**PLANNED UNIT DEVELOPMENT
STAFF REPORT****Date: March 5, 2015**

| <u>DEVELOPMENT NAME</u> | Jack C. Carney and Clare K. Carney |
| <u>LOCATION</u> | 194 Rochester Place (West side of Rochester Place, 115'± North of Airport Boulevard) |
| <u>CONTEMPLATED USE</u> | Planned Unit Development Approval to amend a previously approved Planned Unit Development to allow a reduced front yard setback. |

SITE PLAN

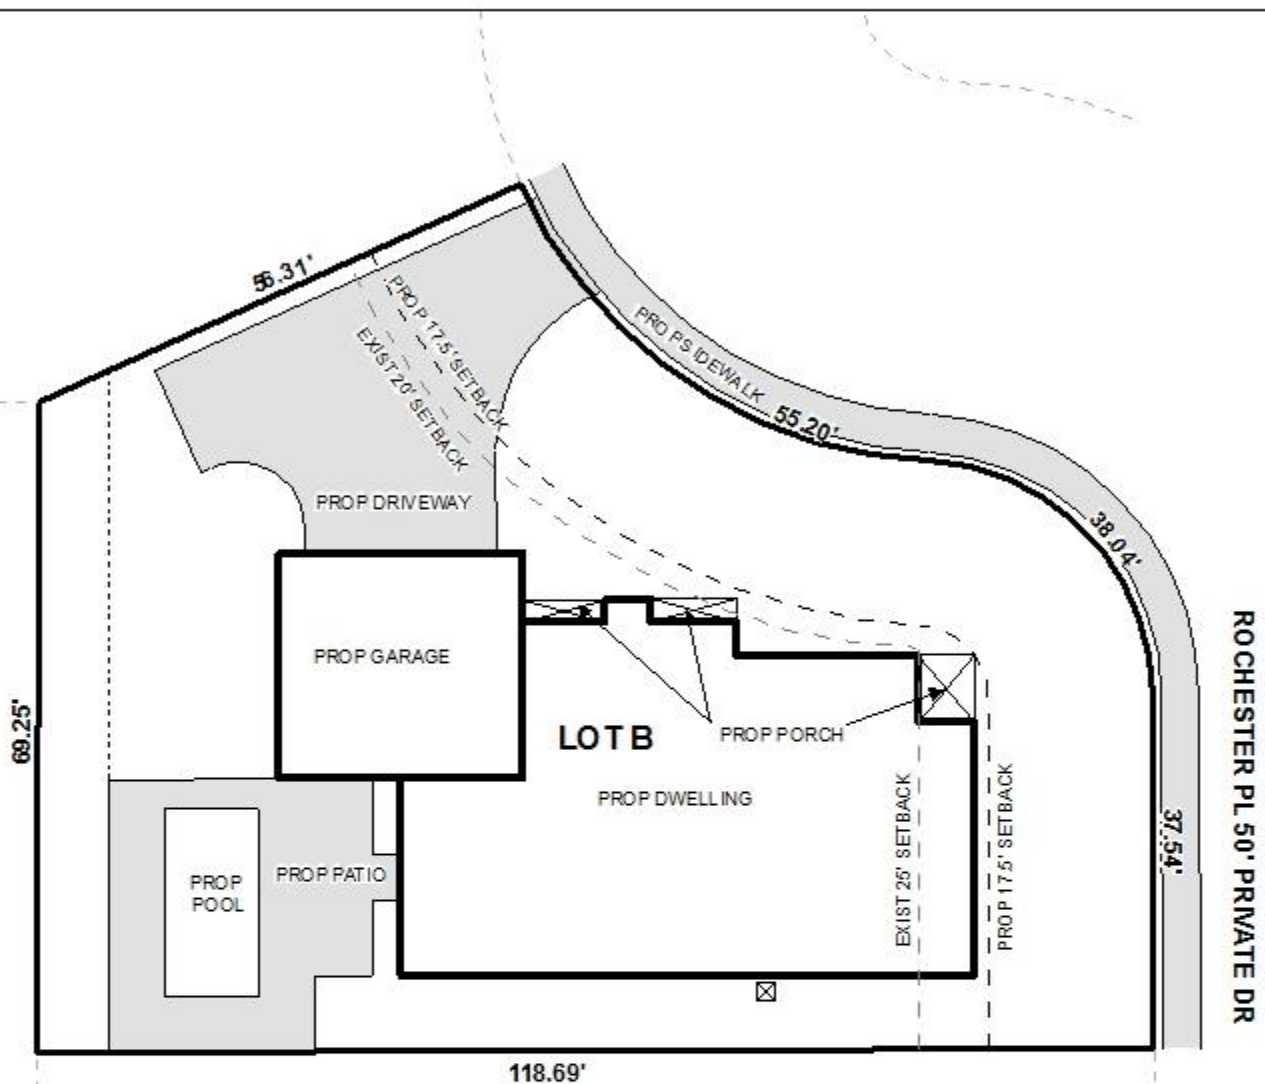
The site is zoned R-1, Single-family Residential, and this district allows up to 35% site coverage and a 25' front-yard setback and 8' side and rear yard setbacks. The site plan depicts the existing 11,500± sq. ft. lot and planned 2,658± sq. ft. residence and, as proposed, the site coverage would be approximately 23%±. The applicant references the tough configuration of the lot as a result of being located along a cul-de-sac, for the need for a reduced front yard setback. All other setbacks and aspects of development in an R-1 district would appear to comply with Section 64-3.C.1. of the Zoning Ordinance.

It should be pointed out that the site plan depicts a 7.5 drainage and utility easement along the lot's western lot line. As such, a note should be placed on the site plan stating that no permanent structure(s) can be placed or constructed in any easement.

Recommended this application be heldover to the meeting of April 2nd, with revisions due by March 9th, to allow the applicant to address the following:

- 1) Submission of a Subdivision Application to the Planning Commission to address the reduction in the front yard setback.
